2.5.2.3 Technical Evaluation

This section of the SER provides the staff’s evaluation of the seismological, geological, and geotechnical investigations the applicant conducted to determine the SSE ground motion for the ESP site. The technical information presented in SSAR Section 2.5.2 resulted from the applicant’s surface and subsurface geological, seismological, and geotechnical investigations performed in progressively greater detail as they moved closer to the ESP site. The SSE is based upon a detailed evaluation of earthquake potential, taking into account regional and local geology, Quaternary tectonics, seismicity, and specific geotechnical characteristics of the site’s subsurface materials.

Figure 2.5.2-7 Regional seismicity for ESP site

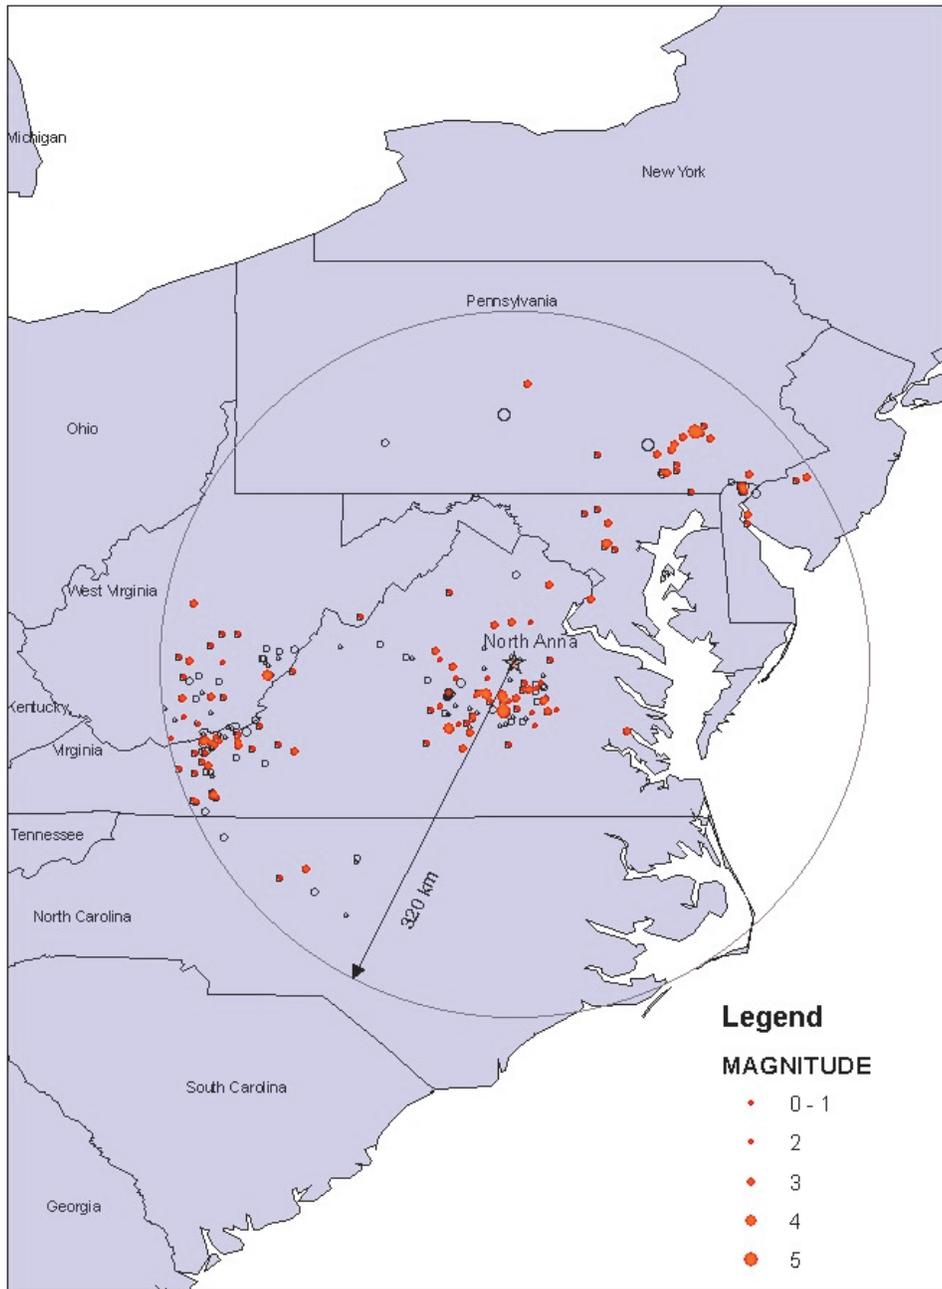
The staff reviewed both the original EPRI seismicity catalog and the update to the catalog. The applicant added 30 more earthquakes to the regional catalog for the ESP site. Figure 2.5.2-7 depicts the earthquake epicenters in the region surrounding the ESP site. The more recent events since 1984 are shown as solid dots. The cluster of seismicity to the south-southwest of the ESP site is from the CVSZ.

Because the applicant used the EPRI seismicity catalog, which is part of the 1989 EPRI seismic hazard study that the NRC endorsed, the staff concludes that the seismicity catalog used by the applicant is complete and accurate through 1984. The staff compared the applicant's update of the regional seismicity catalog with its own listing of recent earthquakes and did not identify any significant omissions. Accordingly, the staff concludes that the applicant accurately updated the regional seismicity.

Figure 2.5.3-1 Site vicinity geologic map and seismicity (25-mile radius)

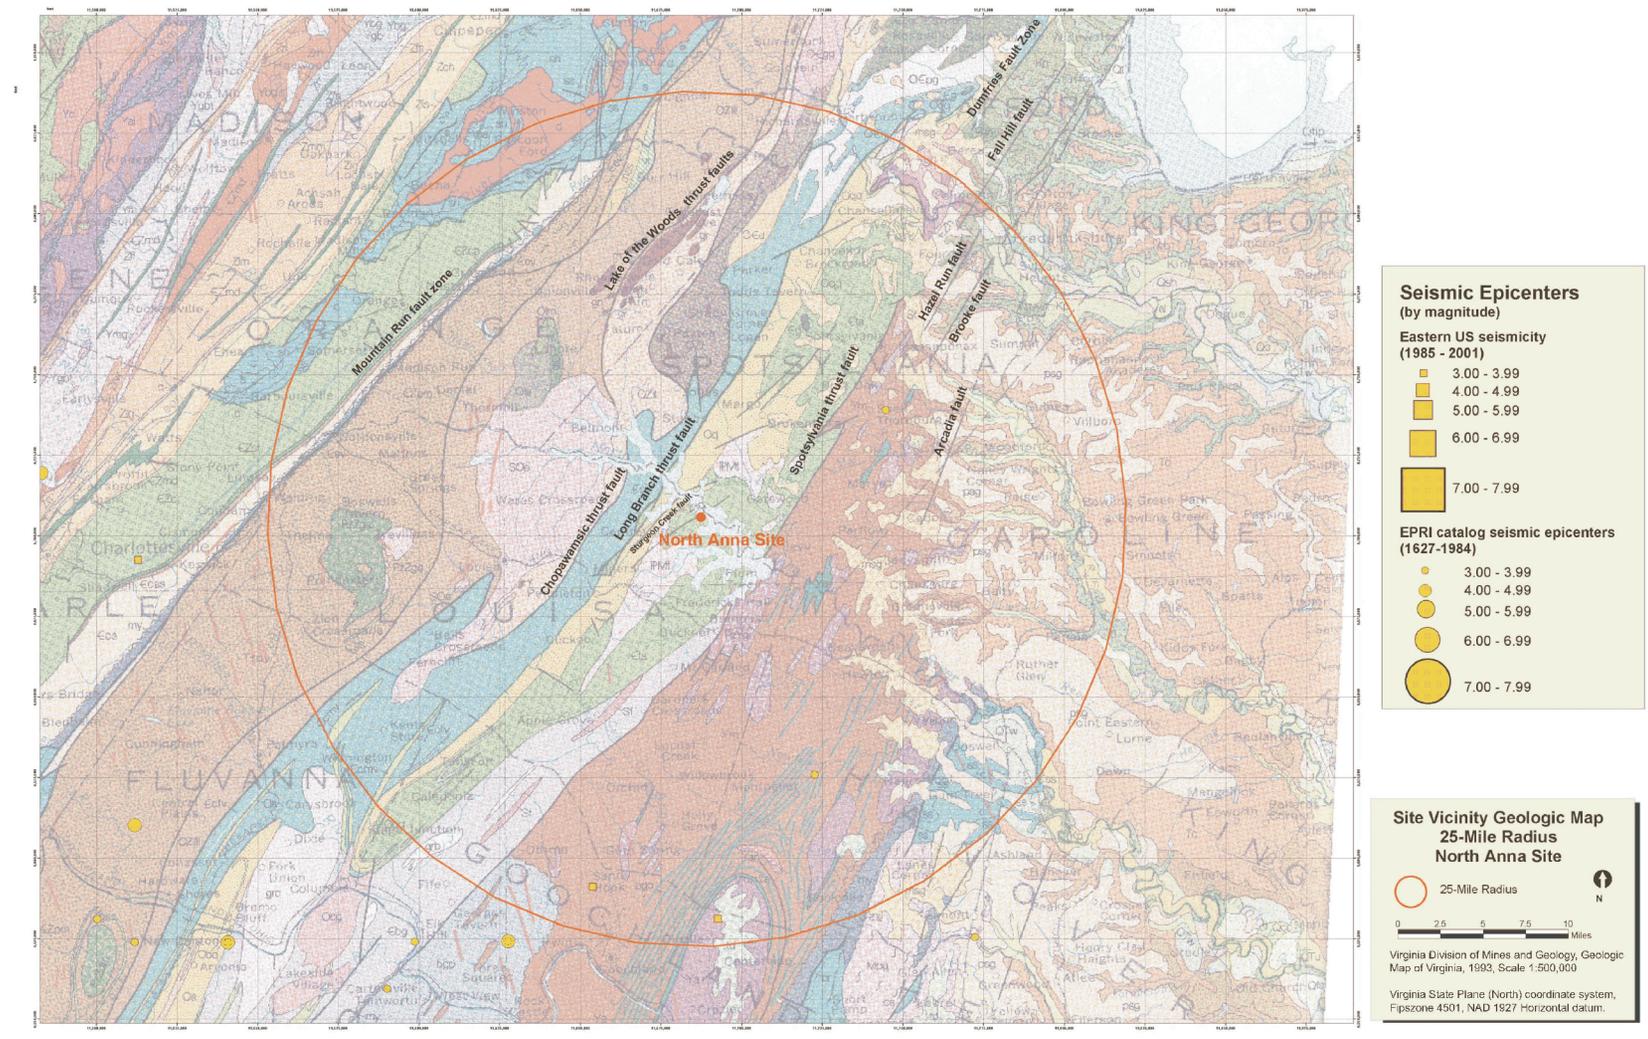
In RAI 2.5.3-1, the staff asked the applicant to provide additional detail on its field investigations and aerial reconnaissance of the site area. In response to RAI 2.5.3-1, the applicant stated that it performed aerial and field reconnaissance along faults within a 5-mile radius of the ESP site. The applicant's reconnaissance emphasized unnamed fault "a" and the Sturgeon Creek fault because of their proximity to the site. In addition, the applicant covered parts of the Spotsylvania, Chopawamsic, and Long Branch faults where these faults were mapped near local roads and/or where they potentially offset plutonic (igneous) margins or metamorphic contacts. Based on the absence of any geomorphic expression indicative of potential Quaternary deformation, the applicant concluded that none of the faults are capable. In addition, the applicant stated that all of the faults in the site area cross gently rolling topography, with relief on the order of 200 ft, and that this rolling topography formed through dissection and erosion of a once broad, continuous Miocene (5-24 ma) pediment that extended across the region. The applicant looked for potential elevation differences in the Miocene pediment gravels across each of the faults that would suggest post-Miocene vertical separation. Based on its field reconnaissance, the applicant did not observe any significant elevation differences. Therefore, the applicant concluded based on its detailed field observations and aerial reconnaissance that, for all seven faults within the site area, no evidence or criteria would suggest Quaternary activity on these structures.

In RAI 2.5.3-2, the staff asked the applicant to further support its conclusion that unnamed fault "a" does not extend beyond the ESP site, as mapped by Pavlides (Ref. 36, SSAR Section 2.5). In its response, the applicant stated that the NAPS licensee discovered fault "a" in 1973 during the foundation excavation for the abandoned NAPS Units 3 and 4 and subsequently mapped fault "a" for a distance of about 3000 ft. Virginia Power did not observe fault "a" in the foundation excavations for the existing Units 1 and 2. The applicant stated that Pavlides, who is deceased, did not provide an explanation for extending fault "a" for a total distance of about 7 miles. Subsequently, Mixon and others (Ref. 66, SSAR Section 2.5) adopted Pavlides' interpretation of the extent of fault "a." The applicant stated that Pavlides did not map any offset stratigraphic contacts in the Lake Anna area to support the mapped location of the fault. In addition, a close inspection of the original mapping by Pavlides compared to the compilation map by Mixon shows that the offsets that are apparently mapped in the stratigraphic contacts appear to be a compilation error. The applicant provided further evidence to support its original mapping of fault "a" in response to RAI 2.5.3-1.

Figure 2.5.4-3 Locations of previous boreholes

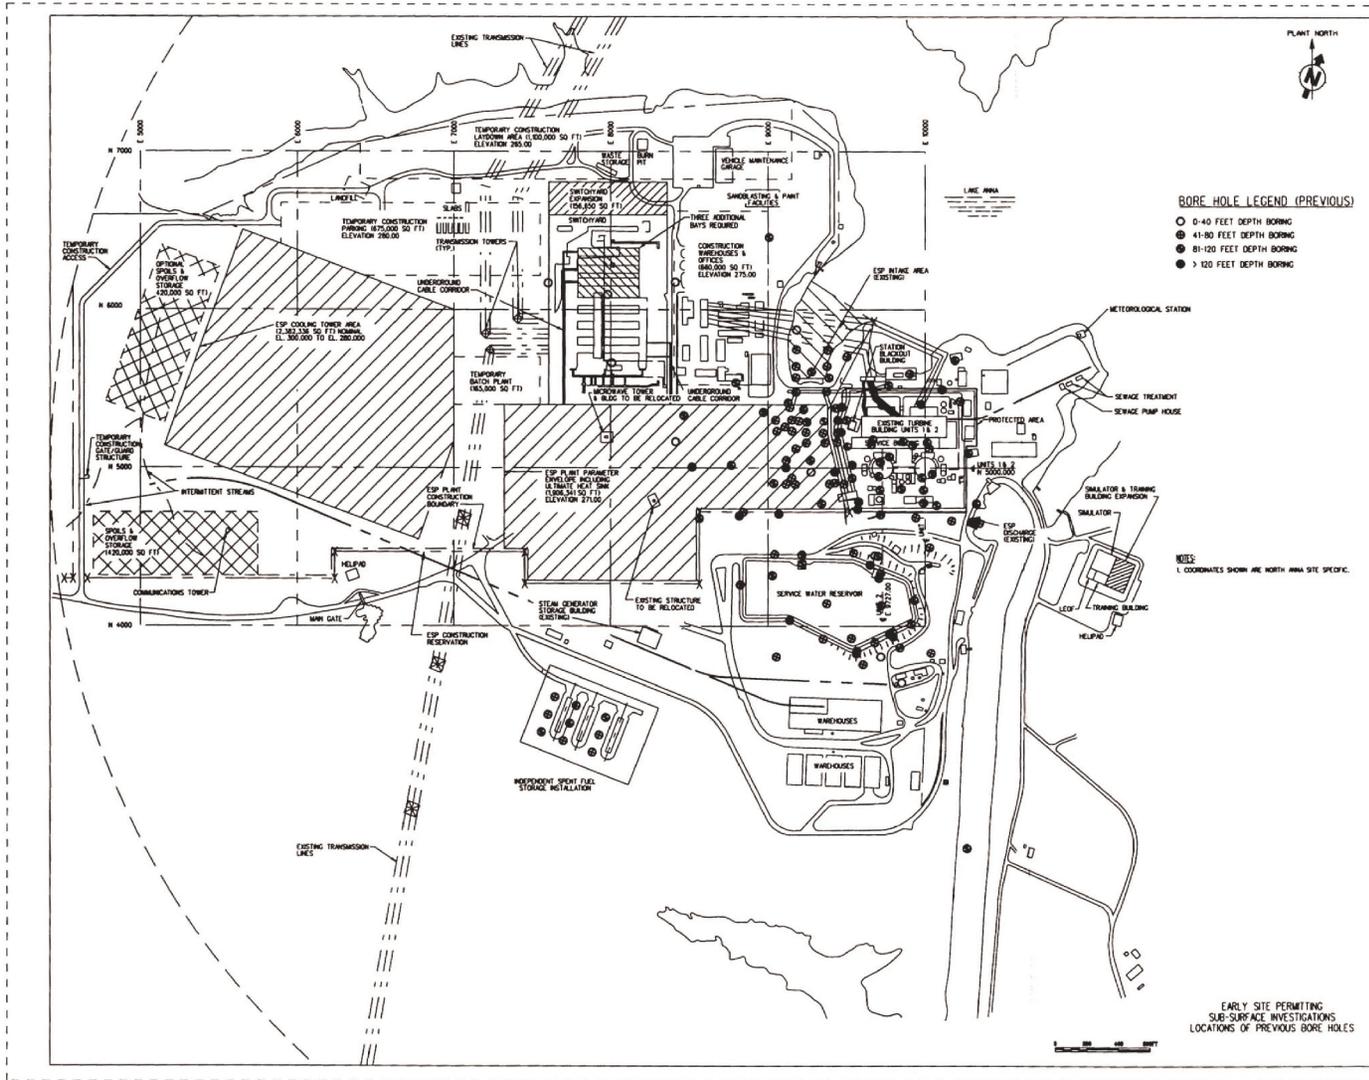
In RAI 2.5.4-1, the staff asked the applicant to provide its basis for concluding that the subsurface conditions in the southeast portion of the ESP footprint (an area of about 500 ft by 1000 ft, in which there are no borings) do not materially differ from conditions in adjacent areas where borings were made. In its response, the applicant stated that the North Anna site is underlain by a consistent geologic profile, which extends to a depth of several thousand feet. The 145 borings performed throughout the North Anna site (including 7 for the ESP) indicate a consistent overall subsurface profile, with expected variations in the thickness of the various strata. As such, the applicant concluded that the southeast portion of the ESP footprint (see SER Figure 2.5.4-3) should be similar to the rest of the site.

Figure 2.5.4-5 Variation of normalized shear modulus with cycle shear strain

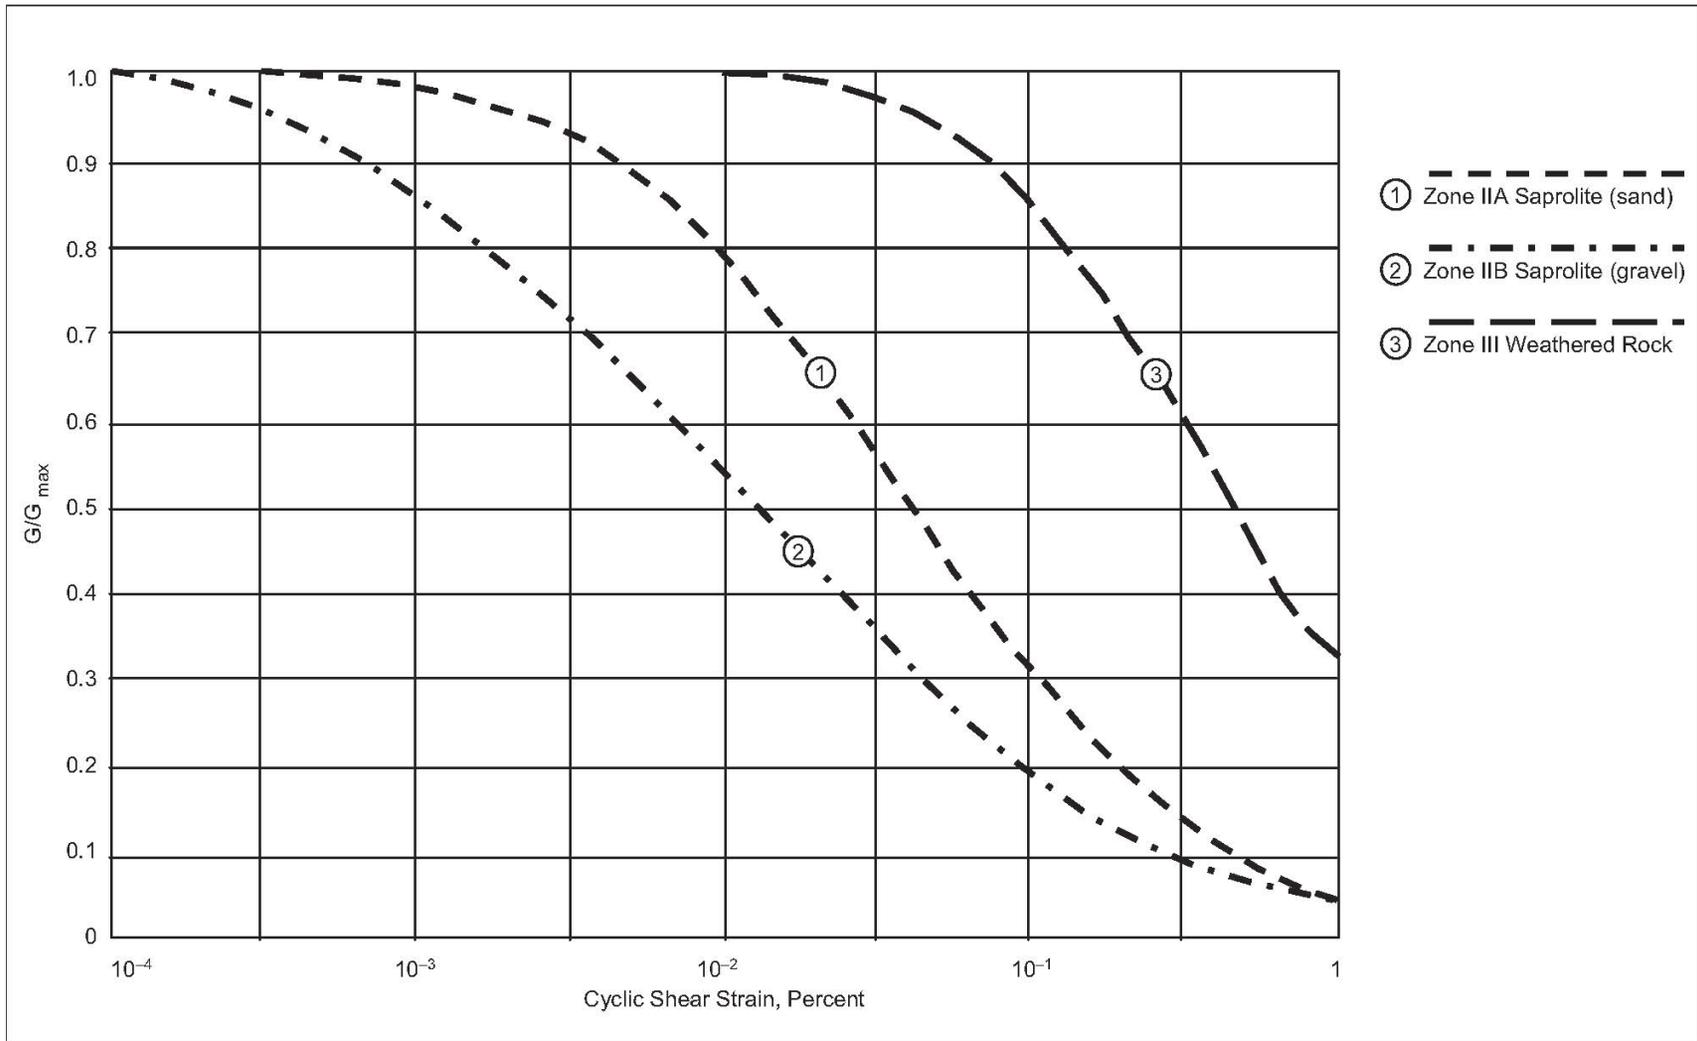
In RAI 2.5.4-8, the staff asked the applicant to provide its basis for the selected modulus reduction and damping ratio curves for Zones IIA, IIB, and III. In its response, the applicant stated that it used the 1993 EPRI report (Ref. 170, SSAR Section 2.5), where applicable, as the basis for the shear modulus reduction and damping ratio curves.

In RAI 2.5.4-8, the staff asked the applicant to provide its basis for the selected modulus reduction and damping ratio curves for Zones IIA, IIB, and III materials. In response to RAI 2.5.4-8, the applicant stated that it used the 1993 EPRI report (Ref. 170, SSAR Section 2.5.2), where applicable, as the basis for the shear modulus reduction and damping ratio curves. The staff reviewed the curves that the applicant selected for each of the soil and rock zones to determine whether the applicant based its selection on appropriate criteria, such as grain size, cohesiveness, confining pressure, and shear wave velocity. The staff concludes that the shear modulus and damping curves selected by the applicant were based on appropriate criteria and are suitable for Zone IIA, IIB, and III soil and rock.

Figure 2.5.4-6 Variation of damping ratio with cyclic shear strain

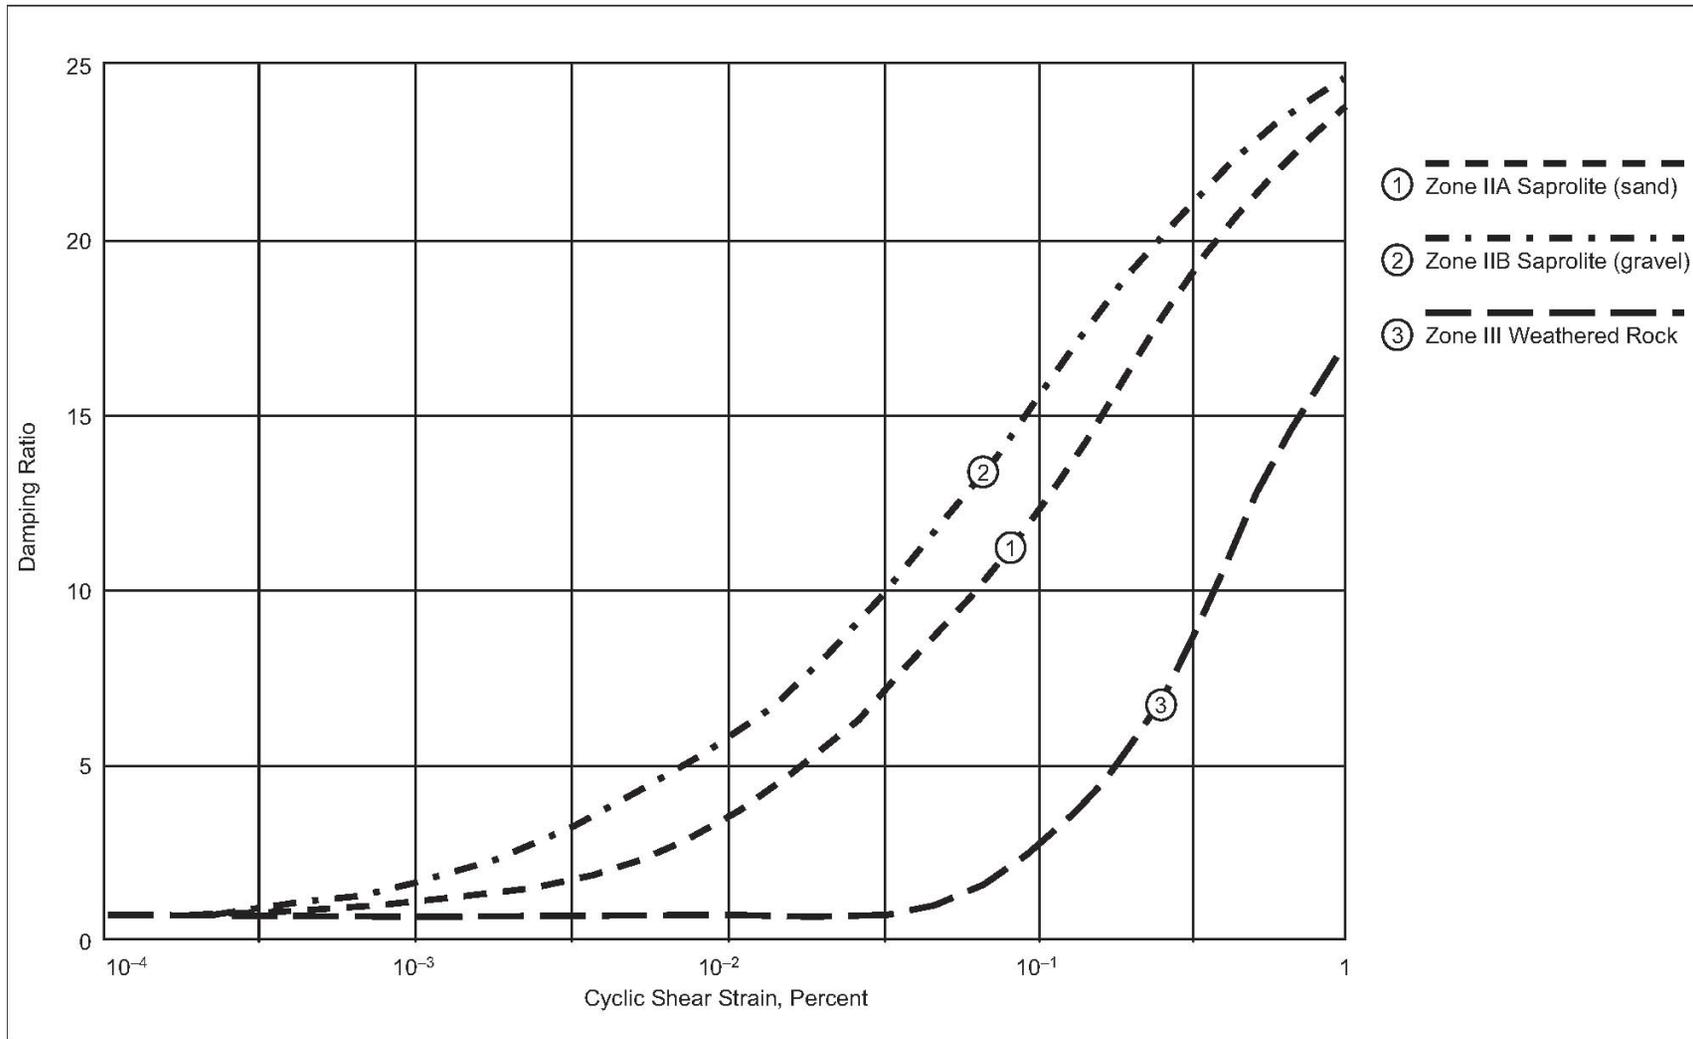
In RAI 2.5.4-8(c), the staff asked the applicant to explain its use of a damping ratio of 2 percent for the Zone III-IV rock. In its response, the applicant stated that the damping ratio for rock varies from site to site depending on the various factors, including the mineral composition of the rock, the integrity and fissuring of the rock mass, and the level of shear deformation in the rock formation. According to the applicant, damping ratios for rock are generally between 0.5 to 4.5 percent. The applicant selected 2 percent for the Zone III-IV rock based on engineering judgment and past experience. To determine the sensitivity of the selected damping ratio, the applicant reran its analysis using damping ratios of 0.5, 1.0, and 5.0 percent. The results show only a slight difference in the peak acceleration for the different damping ratios.

In RAI 2.5.4-8(c), the staff asked the applicant to explain its use of a damping ratio of 2 percent for the Zone III-IV rock. In response to RAI 2.5.4-8(c), the applicant stated that the damping ratio for rock varies from site to site depending on various factors, including the mineral composition of the rock, the integrity and fissuring of the rock mass, and the level of shear deformation in the rock formation. According to the applicant, damping ratios for rock are generally between 0.5 to 4.5 percent. The applicant selected 2 percent for the Zone III-IV rock based on engineering judgment and past experience. To determine the sensitivity of the selected damping ratio, the applicant reran its analysis using damping ratios of 0.5, 1.0, and 5.0 percent. The results reveal only a slight difference in the peak acceleration for the different damping ratios. Based on these results, the staff concludes that a damping ratio of 2 percent for the Zone III-IV rock is acceptable.
